MINGO COUNTY REDEVELOPMENT AUTHORITY  
MINGO COUNTY, WEST VIRGINIA

KERMIT AQUAPONICS FACILITY  
THRASHER PROJECT #101-030-3155

ADDENDUM #4  
January 25, 2019

SHEET No.  
**C-7.0**

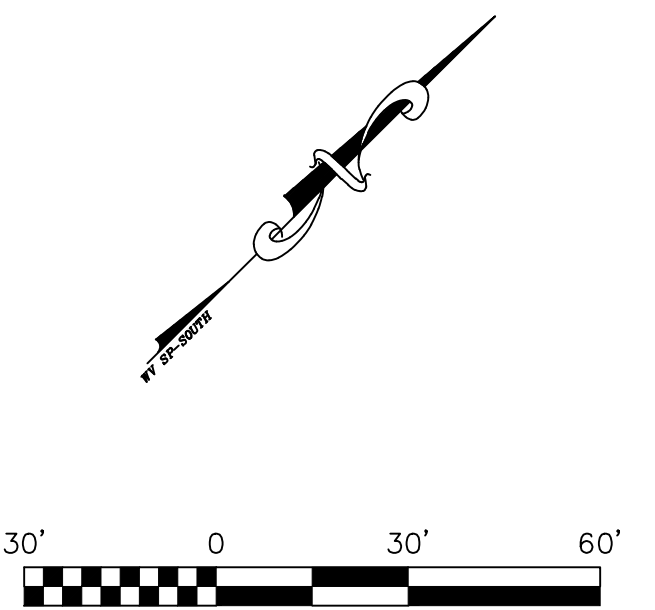
Appears the proposed water line is designed to be installed under the existing caboose location.

Q31B: Who is responsible for the relocation of the caboose?

A: The intent would be to avoid the caboose with the water line. A revised sheet C-7.0 has been provided.

## C-23.0

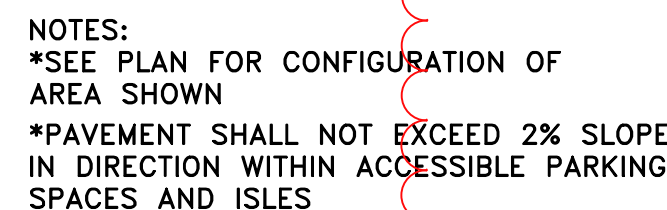
Q11: Drawing C-23.0 calls for a concrete curb and gutter around the parking lot, however, there is no cross-section detail on the curb. Would you care to elaborate on the type of curb and gutter to be installed?

A11: Detail sheet has been revised to delete the curb and gutter and is attached to this addendum.

STANDARD BAT GATE DETAIL  
NOT TO SCALE

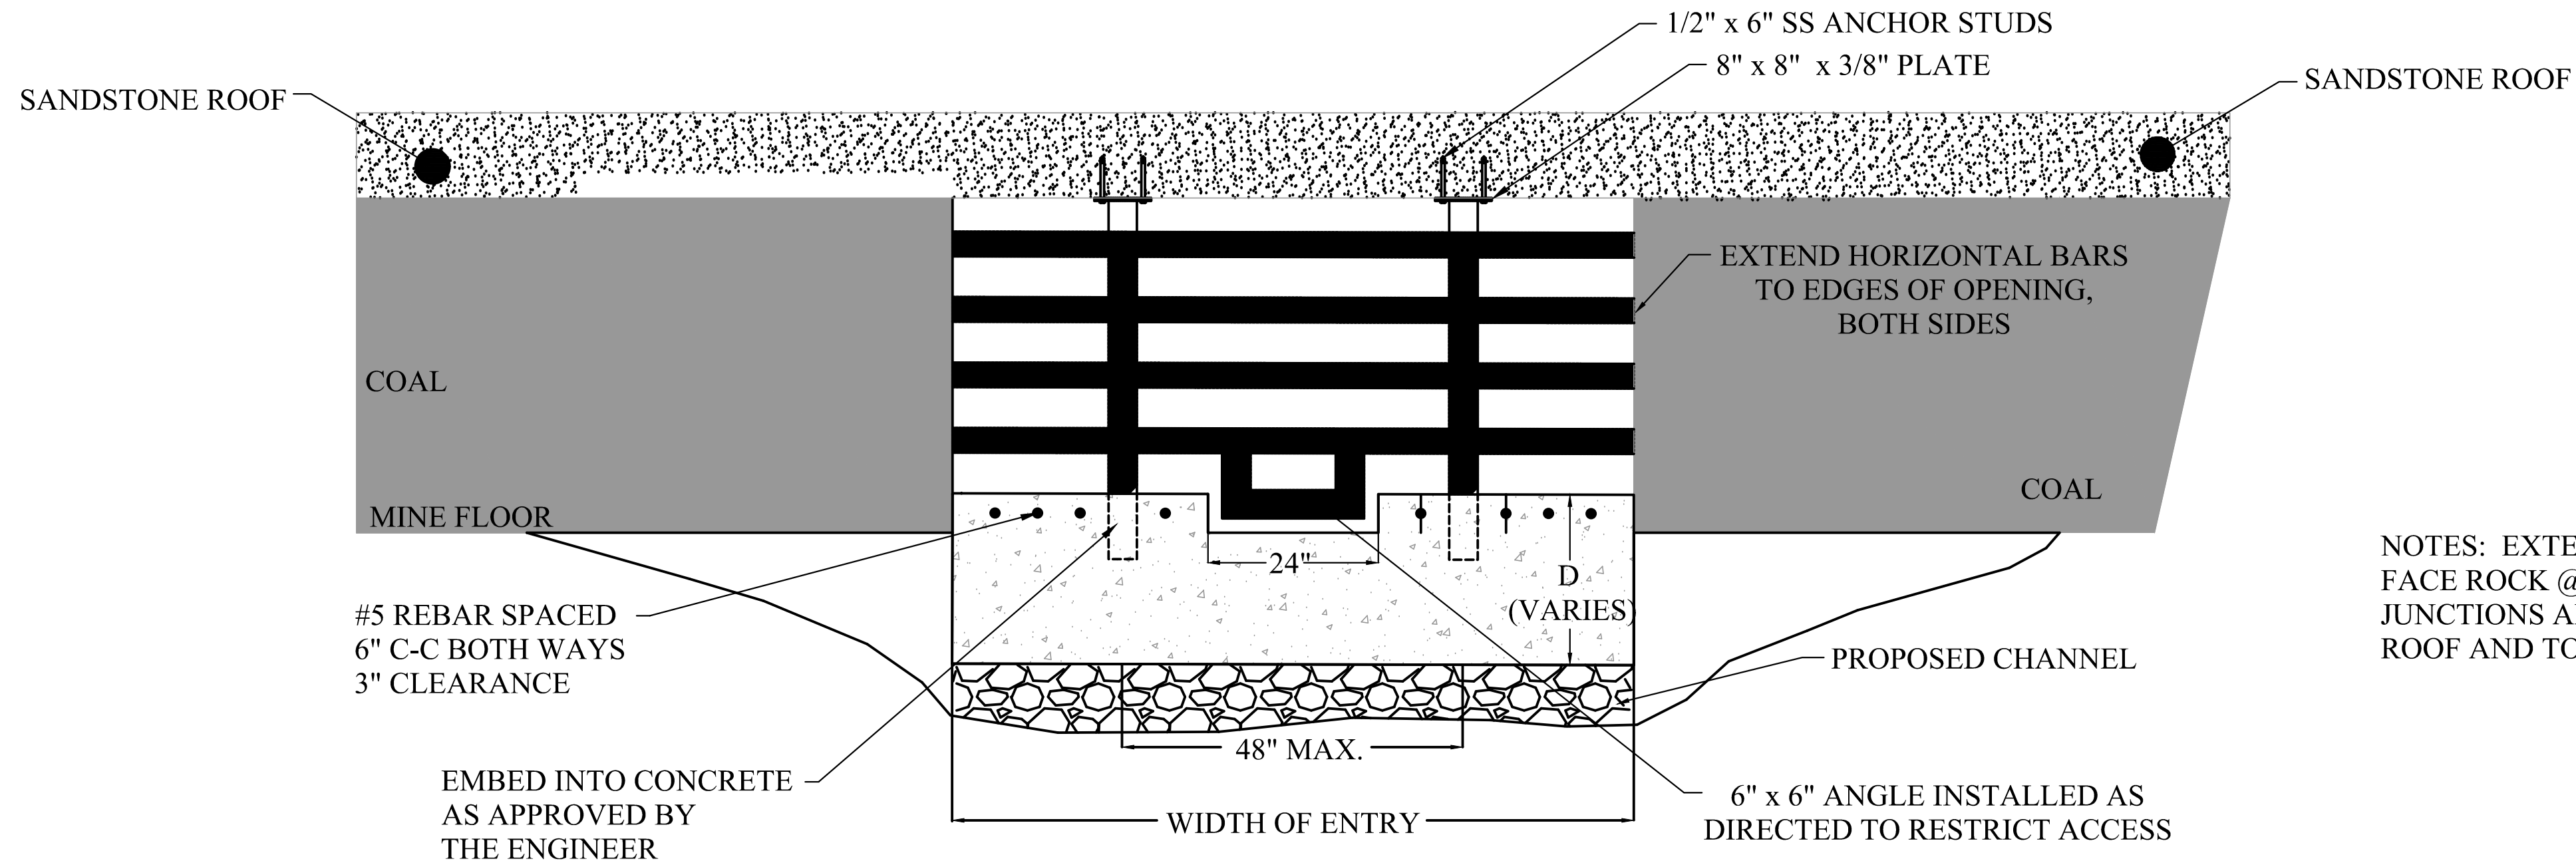
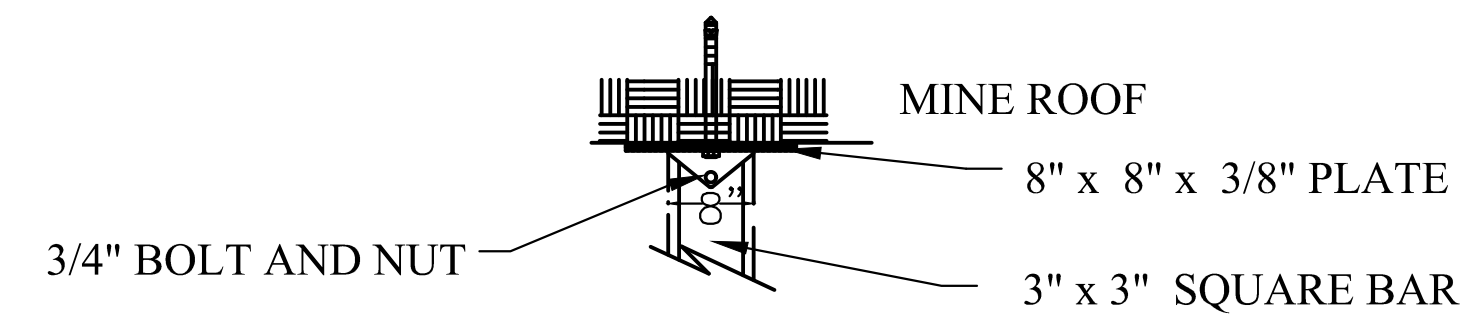
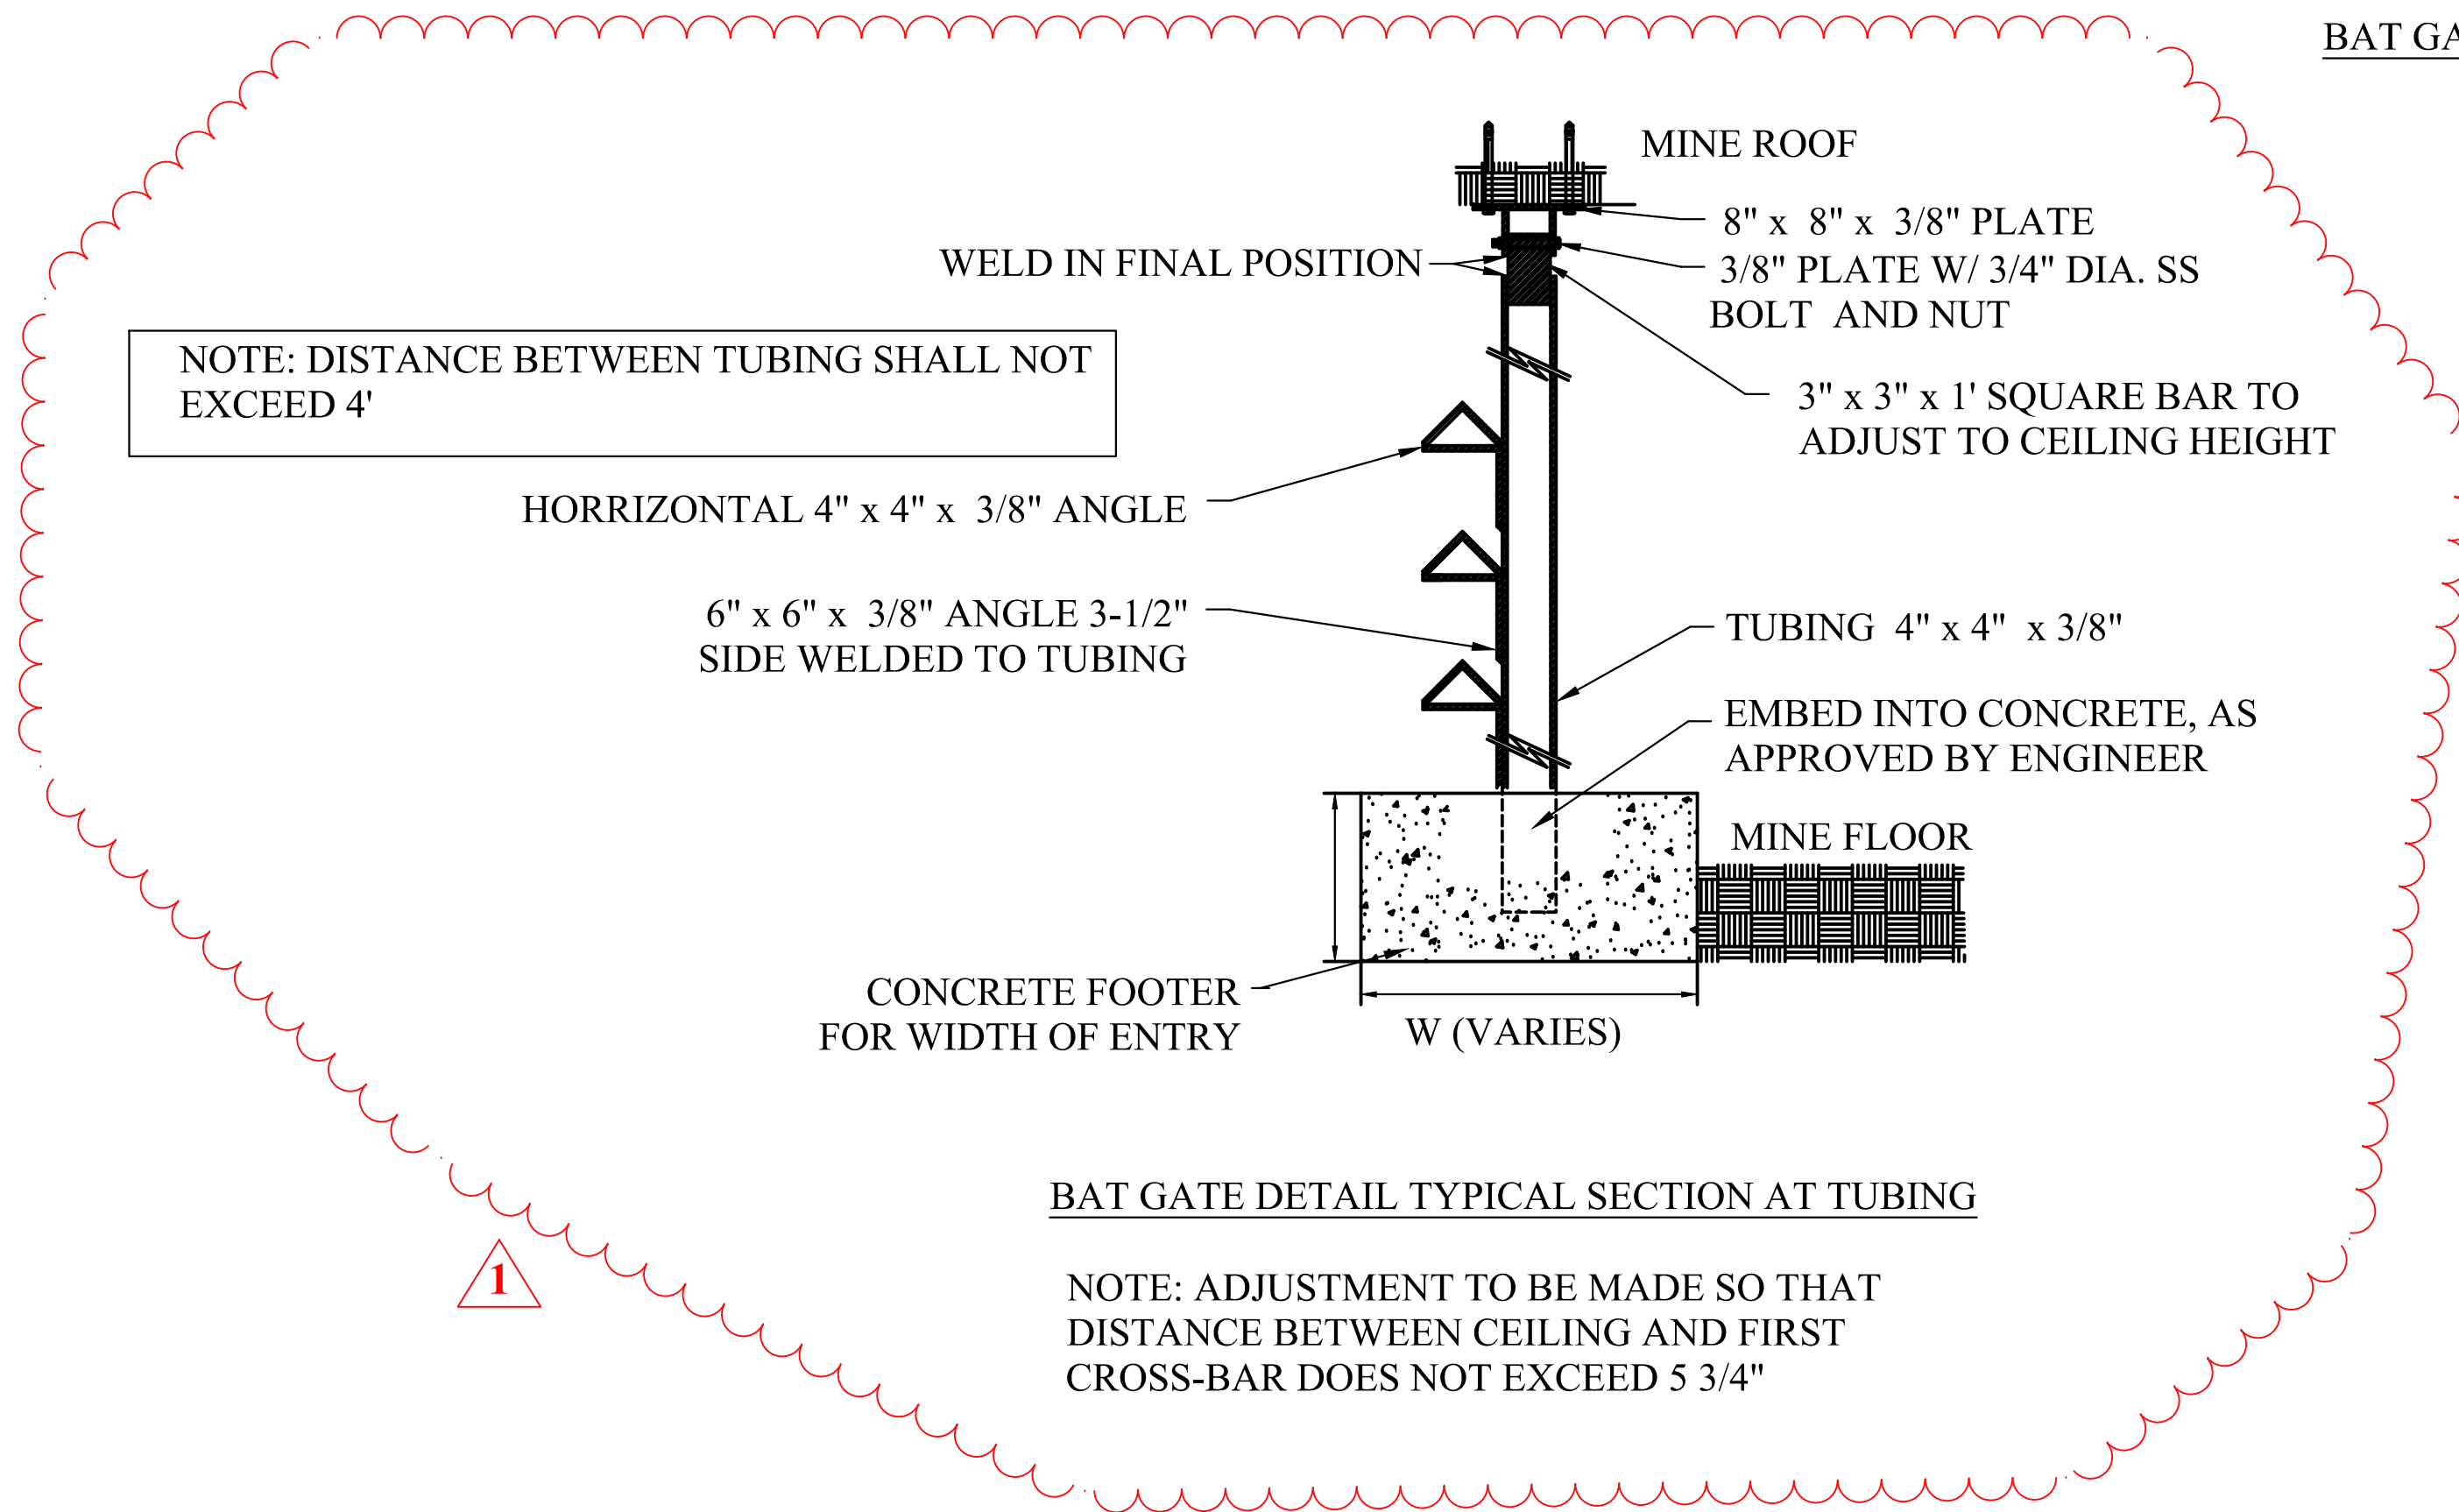
Q8A: The details on sheet C-25.0 indicates the width varies. Could the design team detail engineered drawings identifying precisely what lengths, heights and widths are required? Should this be a bid item based upon lineal foot as identified in article C. 1.4 Method of Measurement?

Q15: What tubing is the note in the rectangle box referring to that is to be 4" cc max?

Q16: The "Horizontal's" are called out as angle 4 x 4 but the dimensions provided in the detail show 6 x 6?

Q18: We cannot determine where the extension lines for the dimensions on the detail point to?

Q21: What are the marks on the top tube to the left in the elevation?"

A15: That is the 4" x 4" x 3/8" steel uprights and the detail should say 4'oc Max.

A16: The detail has been revised for clarification and is attached to this addendum.

A18: The detail has been revised for clarification.

A21: The detail has been revised for clarification.

| 1   | RJH | 1/24/19 | REVISED BAT GATE DETAIL |

P1.01r

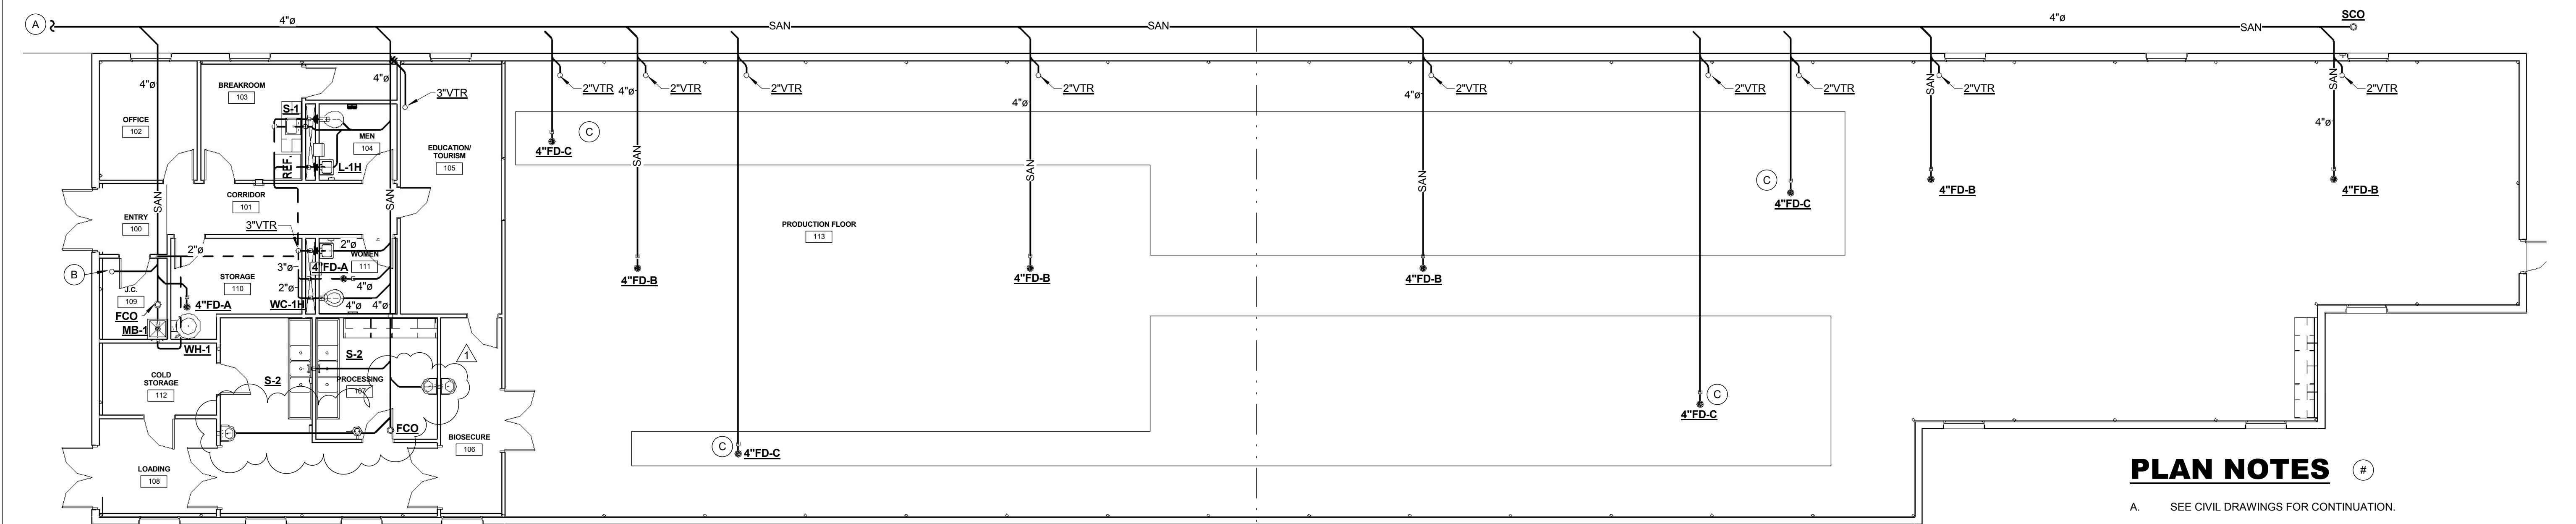
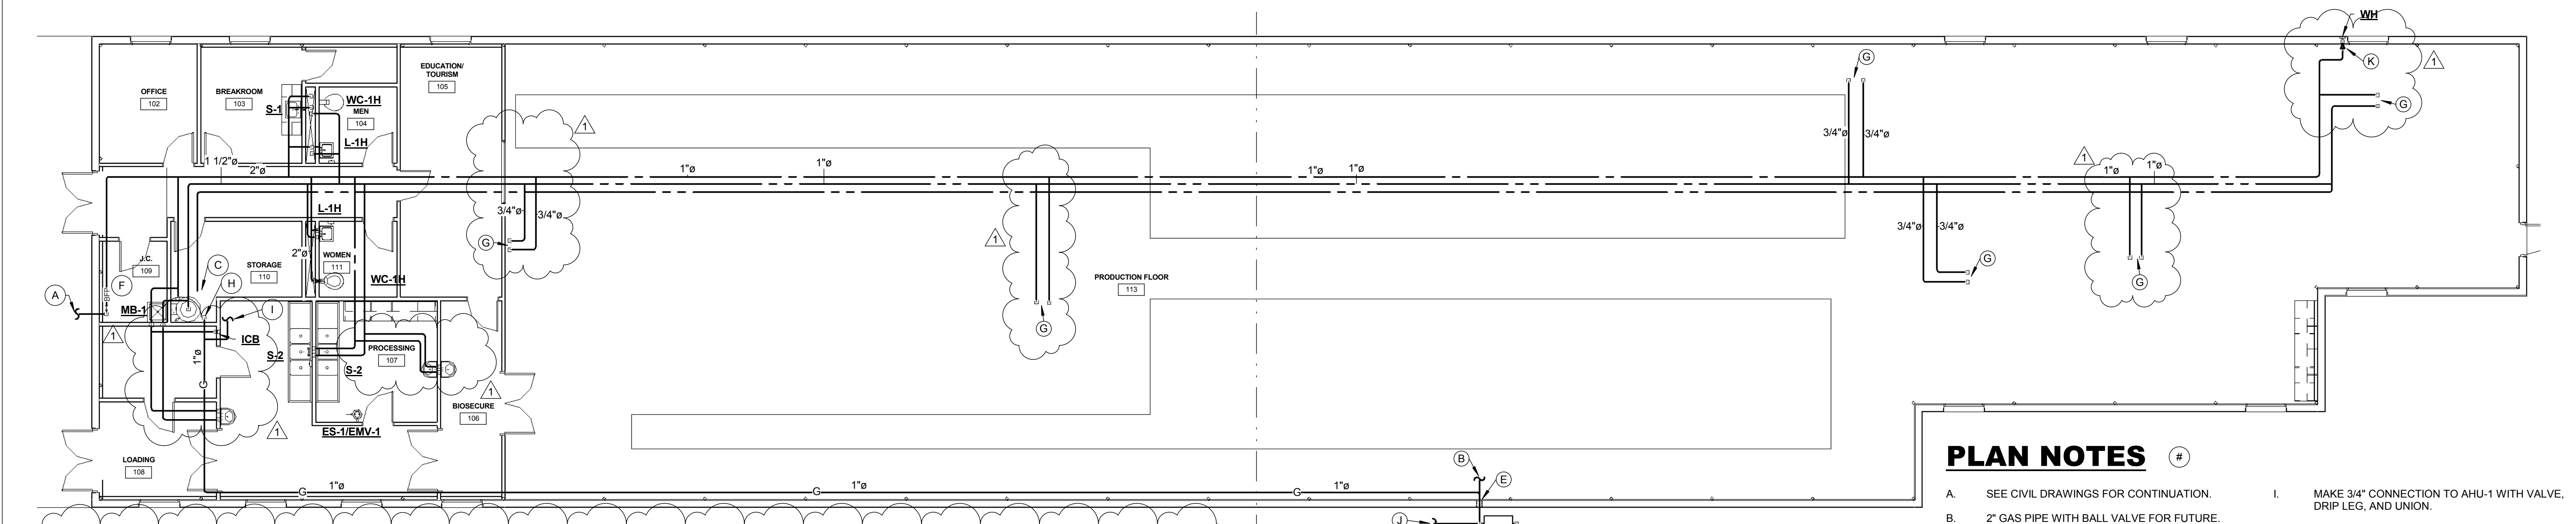
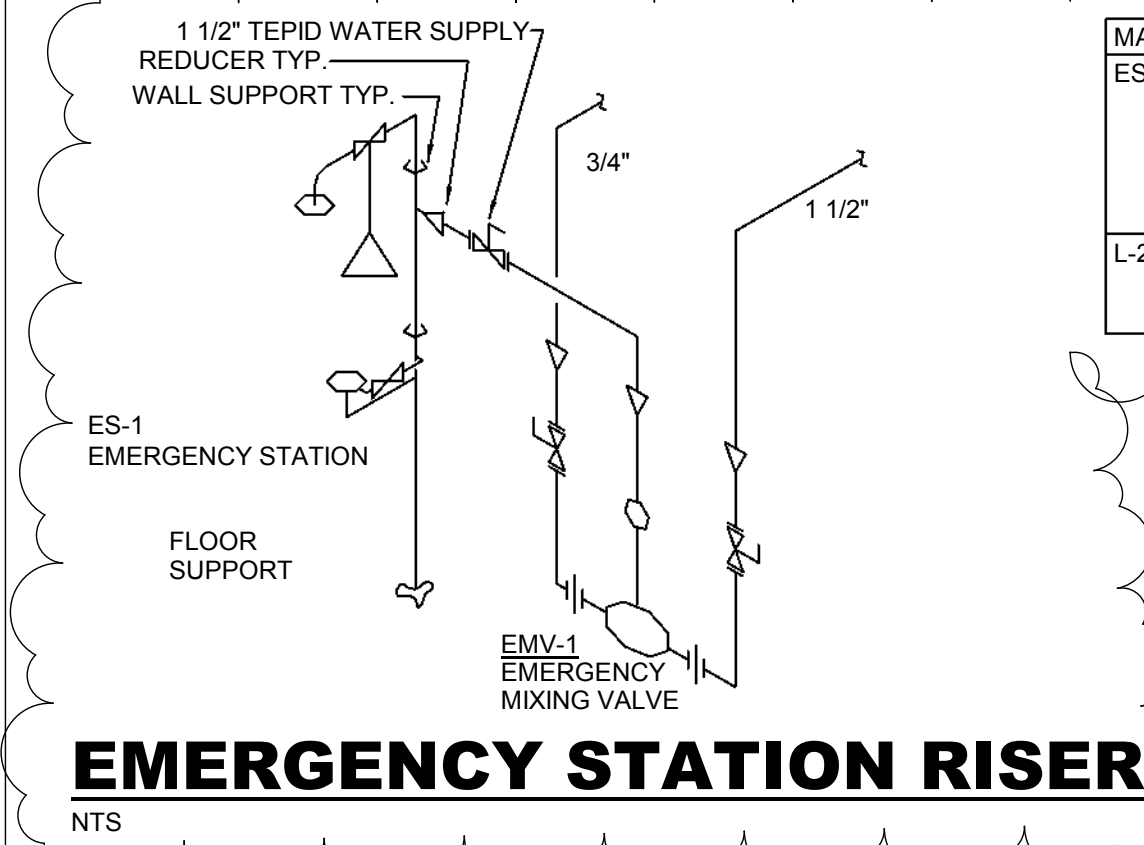
Q47: Sheet P1.01
